# City of Portland, Maine – Building or Use Permit Application 389 Congress Street, 04101, Tel: (207) 874-8703, FAX: 874-8716

# BUILDING PERMIT REPORT

DATE: 15 Dec. 2000 ADDRESS: 107 MILTON ST. CBL: 336-H-040

REASON FOR PERMIT: Amend. Perm. 7 #000954 add deck

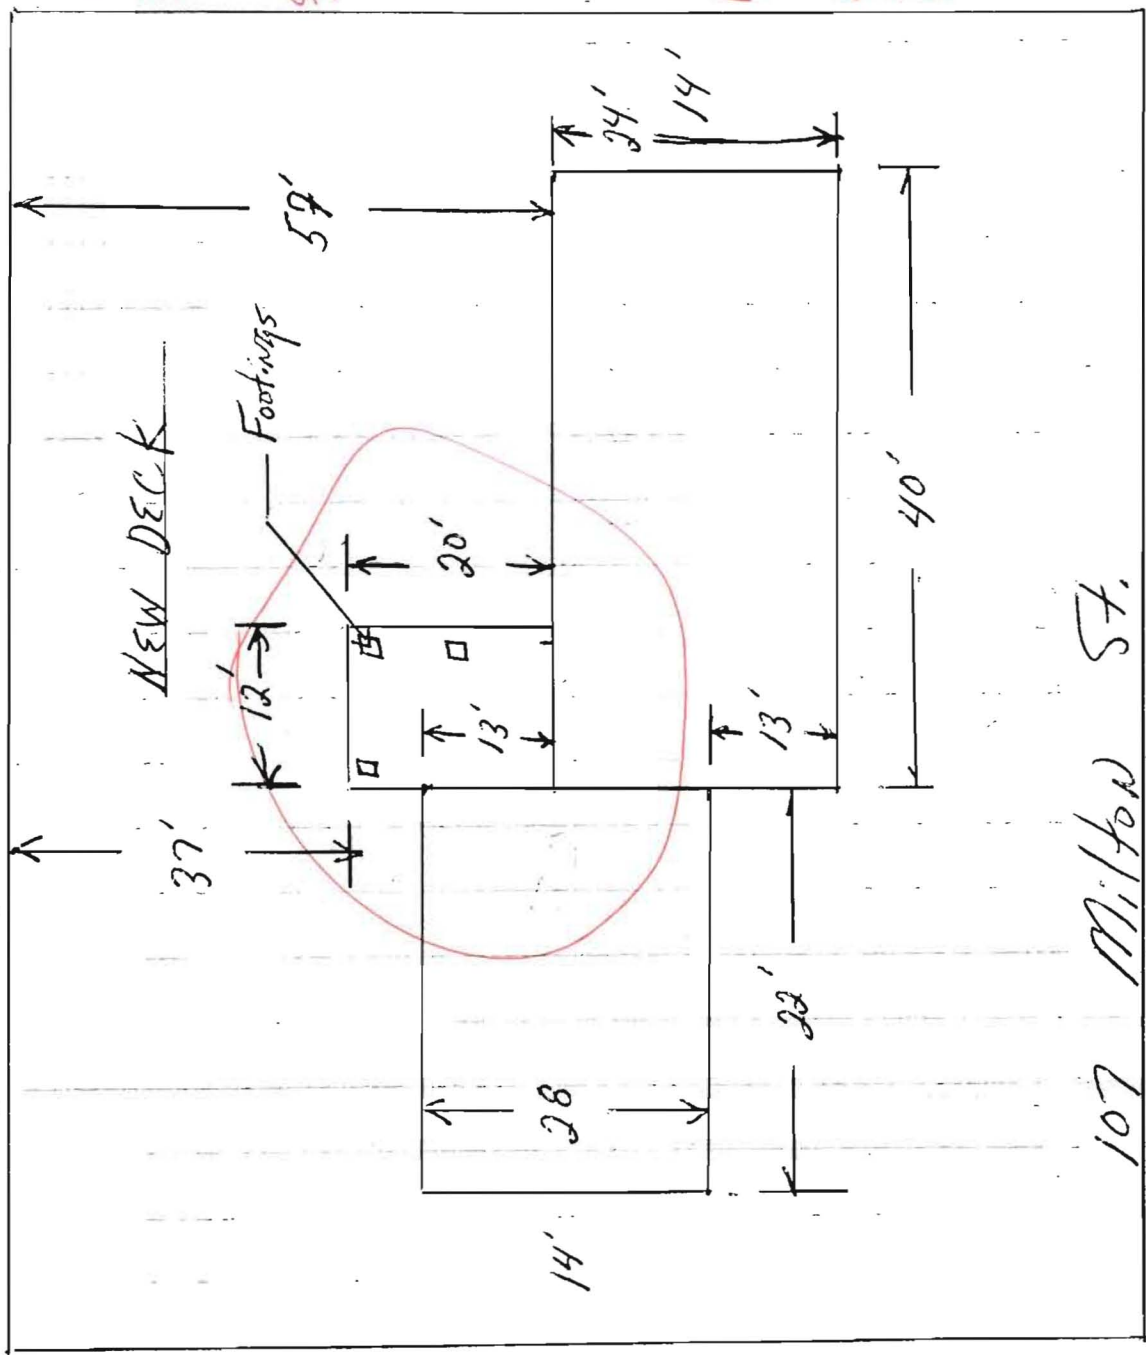
REAR: 25' reg -  
37' Show

SIDES: 14' reg -  
14' + show  
OK

Lot coverage:  
 $10,000 \times 206 = 2,000$

OVER FOR DECK PLAN

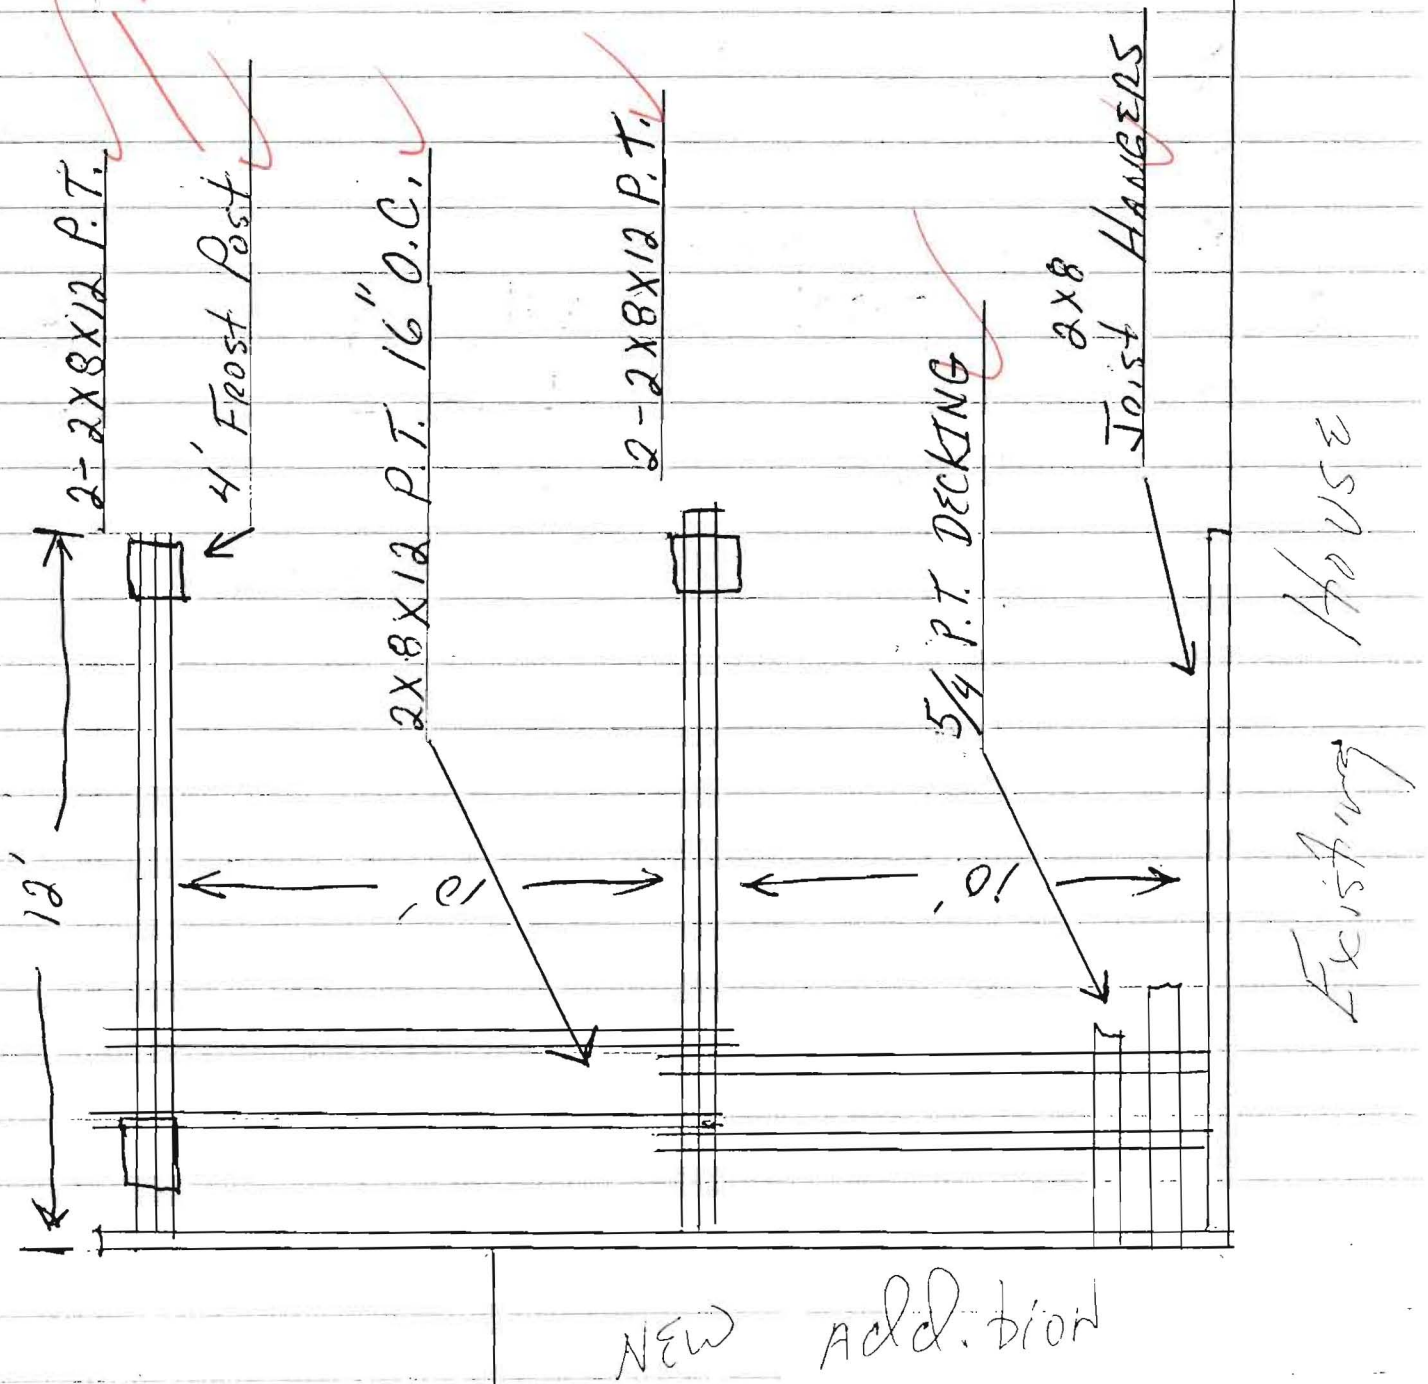
31. Please read and implement the attached Land Use Zoning report requirements. *There shall be NO exterior open stairways from this deck to the ground. Any stair*

X 32. Boring, cutting and notching shall be done in accordance with Sections 2305.3, 2305.3.1, 2305.4.4 and 2305.5.1 of the City's Building Code. *shall be interior and enclosed*

on Footing?

A RAILING SYSTEM 42" HIGH - LESS THAN 4" SPACES
